APPLICANT:			PETITION No.:	V-61	
PHONE:				DATE OF HEARING:	05-11-2016
REPRESENTA	TIVE: Fer	nando Calvo		PRESENT ZONING:	R-30
PHONE:	404	4-751-6509		LAND LOT(S):	1093
TITLEHOLDE	R: Arlene	Lane Connor		DISTRICT:	17
PROPERTY LO	OCATION:	On the west side	of	SIZE OF TRACT:	1.28 acres
Atlanta County Club Drive, on the south side of Burning				COMMISSION DISTRICT:	2
Tree Drive (760	Atlanta Coun	try Club Drive).			
TYPE OF VAR	IANCE: V	Vaive the rear setba	ack from th	e required 40 feet to 15 feet.	
OPPOSITION:	No. OPPOS	SEDPETIT	TION No	SPOKESMAN	
BOARD OF AP	PEALS DEC	CISION	7		
APPROVED	MOTIO	N BY	_		Pives X
REJECTED	SECONI	DED		Or Be Cit William	andibr
HELD	VOTE		/	No cor	2001

APPLICANT:	Arlene L. Connor	PETITION No.:	V-61
	· ·		<u>`</u>

COMMENTS

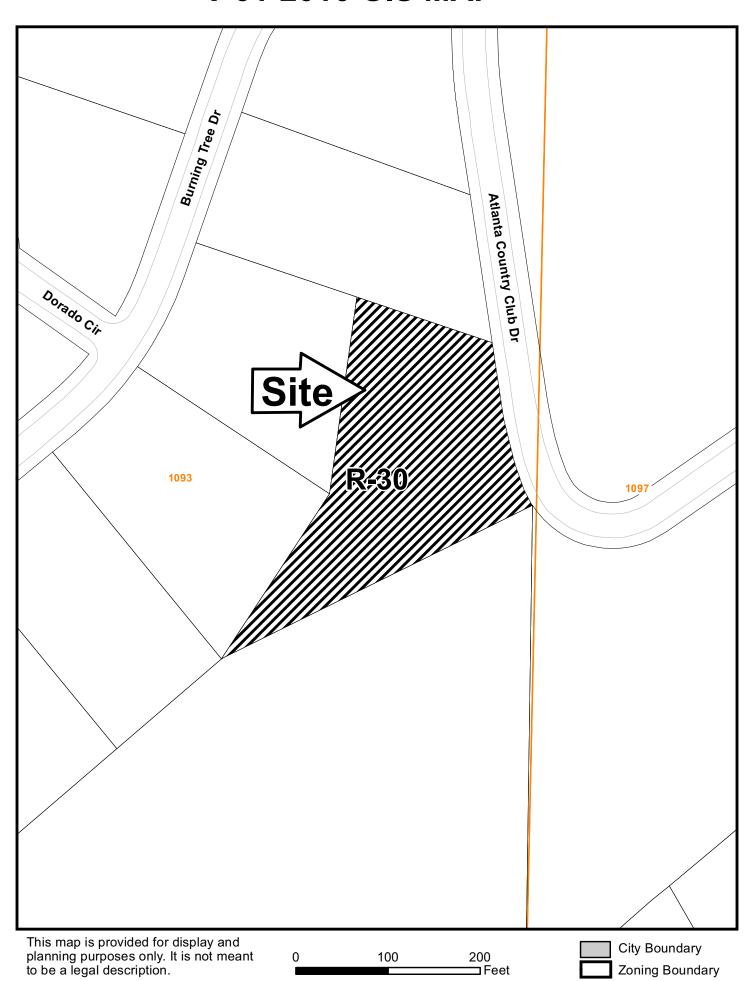
SEWER: New home must be minimum 10' from edge of sanitary sewer easement. The existing concrete wall appears to be in the sewer easement setback, in violation of County Code 122-123
